CITY OF AUSTIN
Board of Adjustment
Decision Sheet
E-3

CASE NUMBER: C15-2021-0056

ADDRESS: 3006 GLENVIEW AVE

VARIANCE REQUESTED: The applicant is requesting a variance(s) from the Land Development Code, Section 25-2-515 (*Rear Yard of a Through Lot*) from setback requirements to decrease the minimum rear yard setback from 25 feet (required) to 5 feet (requested) in order to erect a detached garage/office in an “SF-3-NP”, Single-Family Residence-Neighborhood Plan zoning district. (Windsor Road Neighborhood Plan)

PLT_PLAN

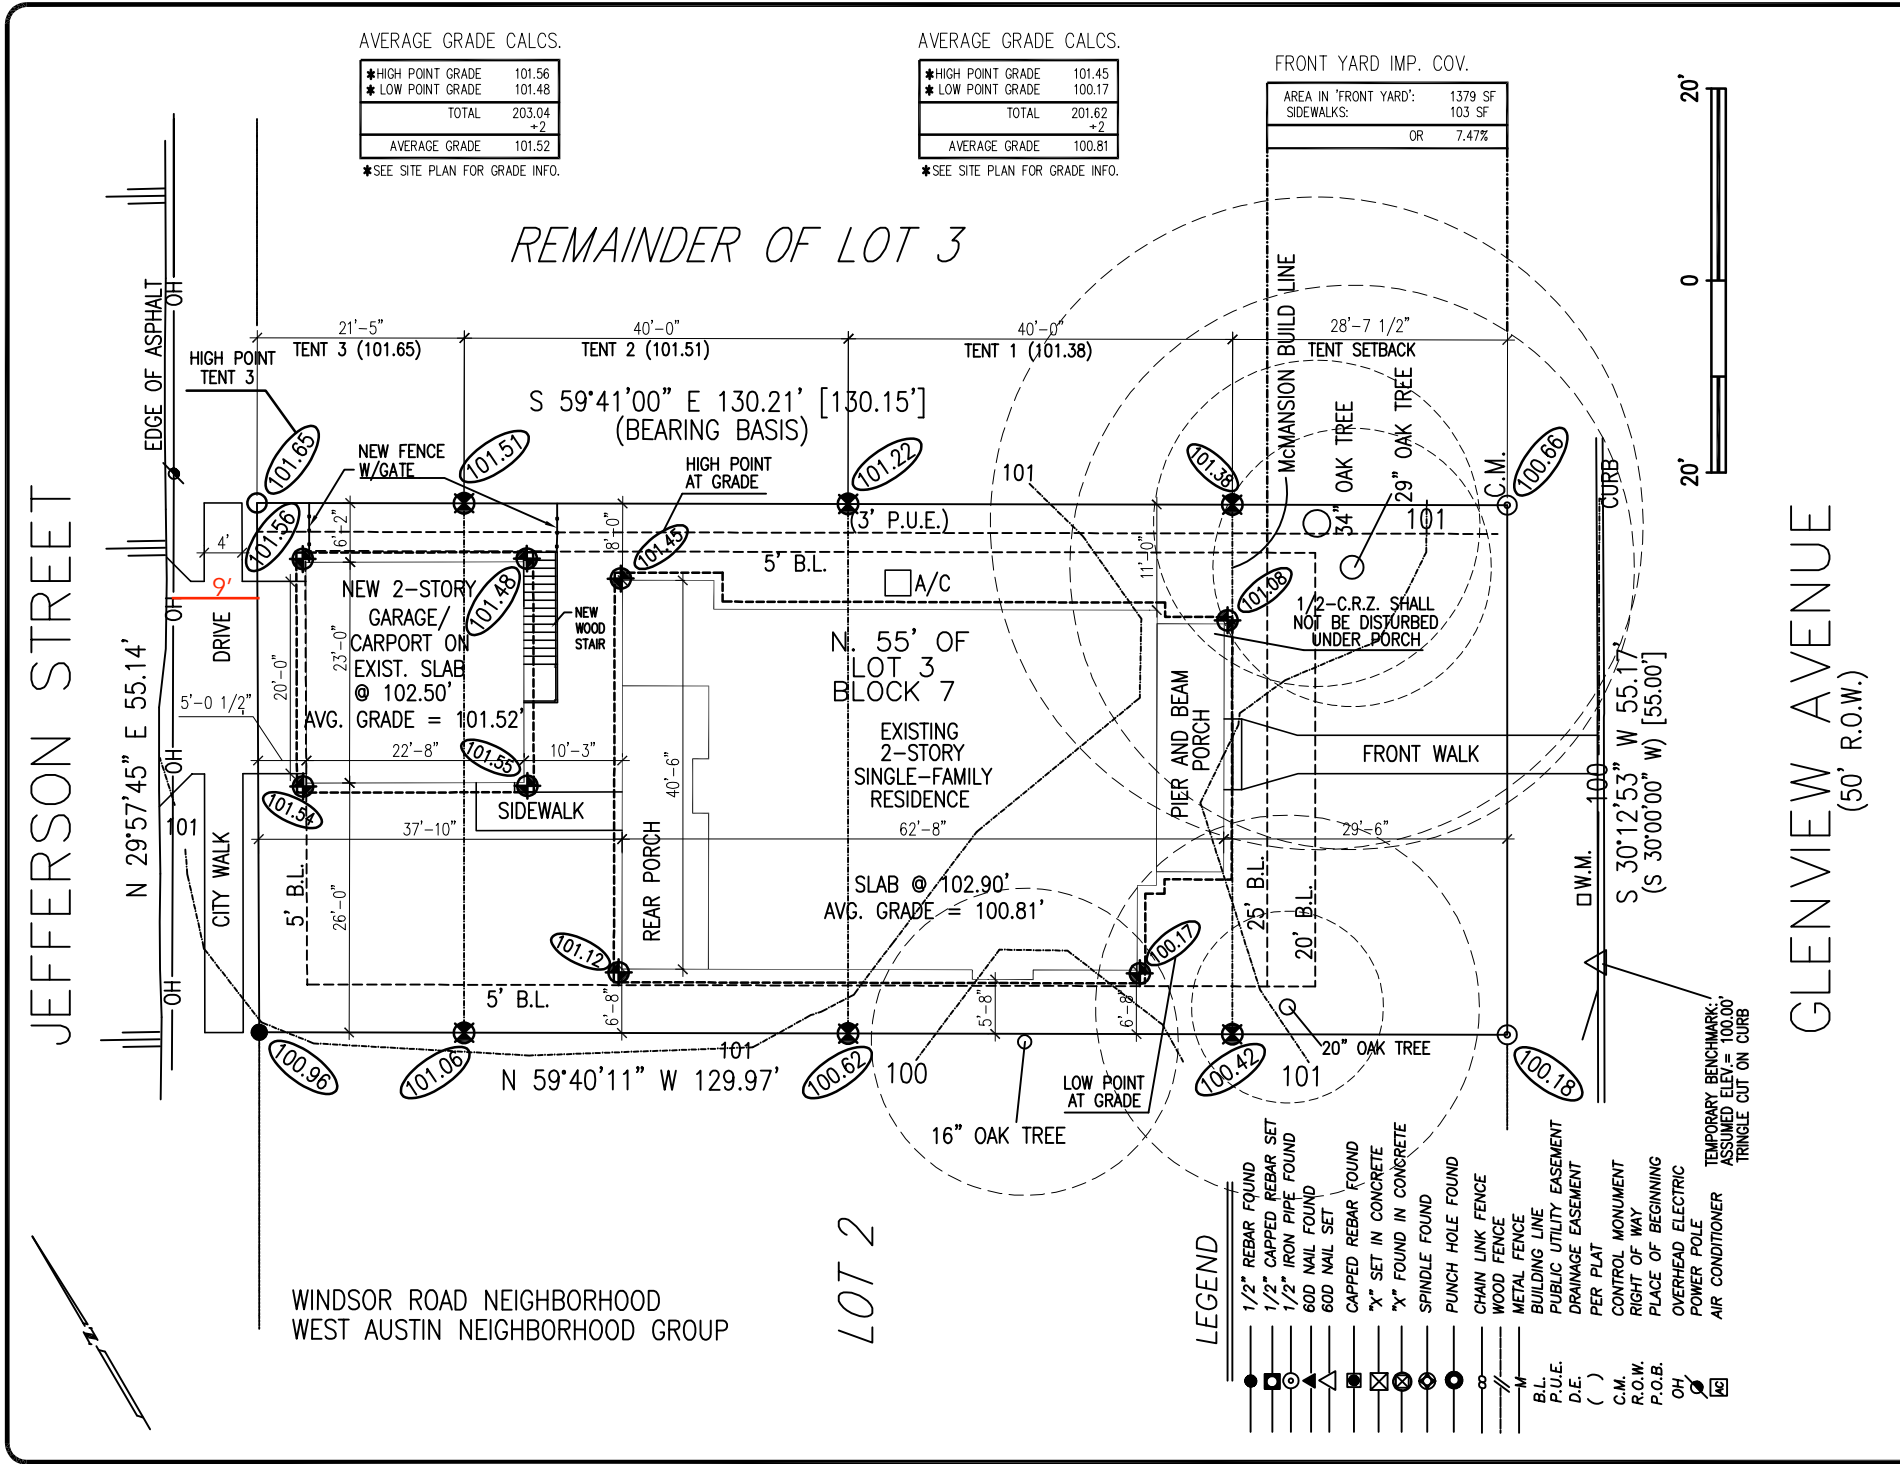
Austin Energy (AE) has reviewed your application for the above referenced property, requesting that the Board of Adjustment consider a variance(s) from Land Development Code Section 25-2-515 (Rear Yard Through Lot) in order to reduce the required rear setback from 25' to 5'. Austin Energy **opposes** approving this request until further detail regarding clearances can be provided.

While the request is similar to others approved in the area, for complete assurance, Austin Energy requests that the owner/applicant provide elevations of the proposed new structure, showing the building is able to meet the minimum horizontal clearance of 7 feet 5 inches from the outmost conductor, as required by Austin Energy's Design Criteria Section 1.10.0 (clearance & safety requirements). Below is a link to Austin Energy's Design Criteria, as well as a diagram depicting the horizontal and OSHA clearances required.

Distance from the Center OH Line to the build line is 9'. Distance from BL to the structure is 5'0.5". Utility Pole has a cross beam 8' wide making the closest line approximately 5' from the BL. Therefore, distance from structure to the closest OH line is approximately 9.5'.
